**ADDRESS: 1021 CHESTNUT ST**

Proposal: Remove structure, construct structure, reconstruct façade

Review Requested: Final Approval

# PPA GARAGE HISTORIC PRESENTATION

RECONSTRUCTED SOUTH ELEVATION  
3/16" = 1'-0"

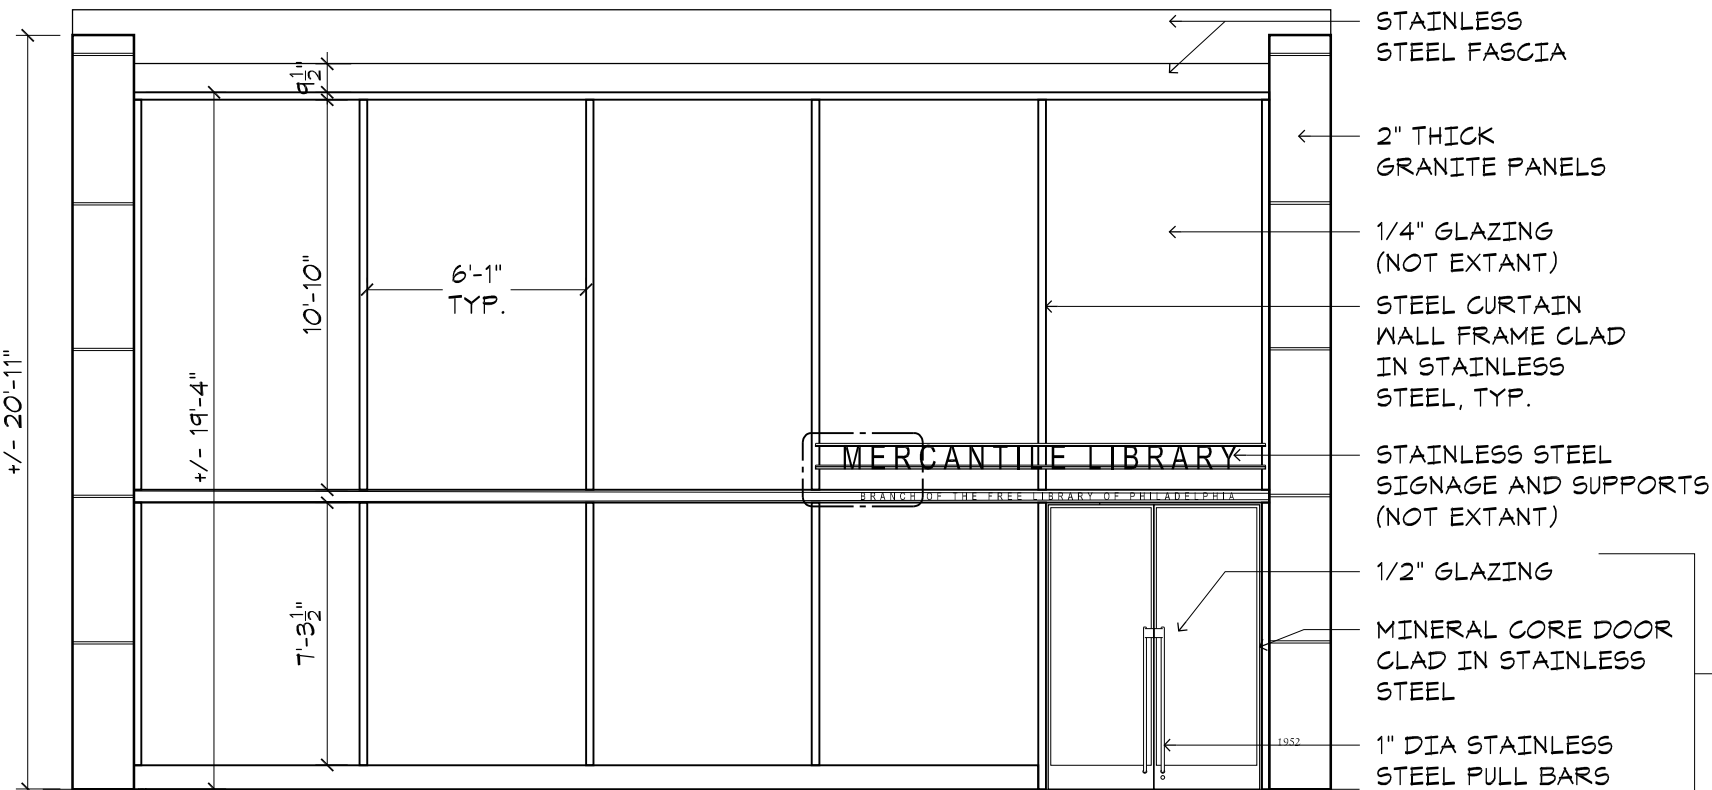
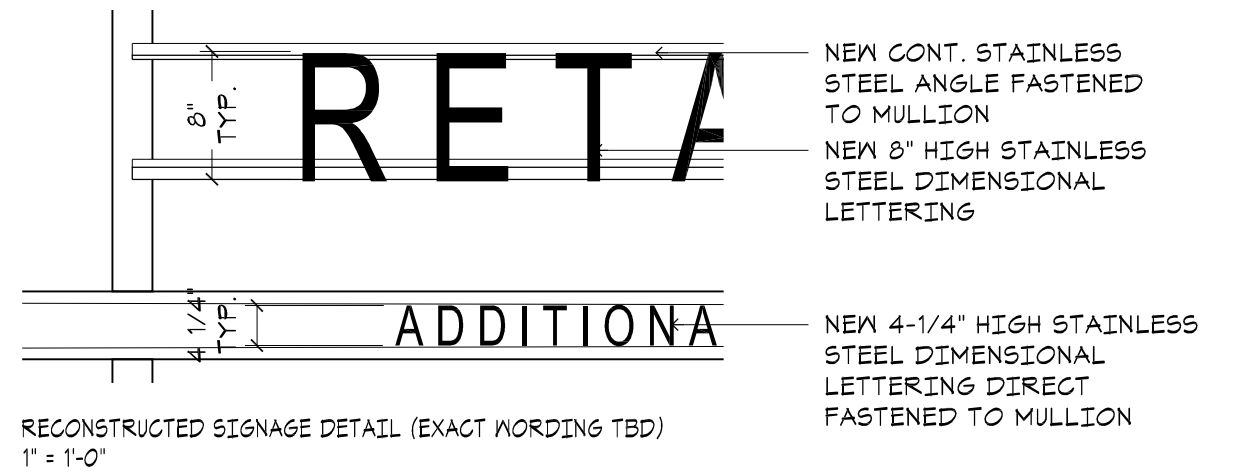
The application proposes to remove most of the library structure, construct a parking garage with ground-floor retail on the site and adjacent site, and reconstruct the front façade to replicate the historic library façade. The application demonstrates that the stainless steel and glass portion of the front façade of the library is severely deteriorated and cannot be salvaged. The masonry-clad piers at the outer edges of the front façade would be retained and incorporated into the reconstructed façade. Behind the façade, the new structure would include retail space at the first floor and parking decks above. The Chestnut Street elevation above the rebuilt façade would be clad in a screen of metal fins.

- The severity of the deterioration of the front façade necessitates its replacement. The new façade will match the old façade in all respects. This project satisfies Standard 6.
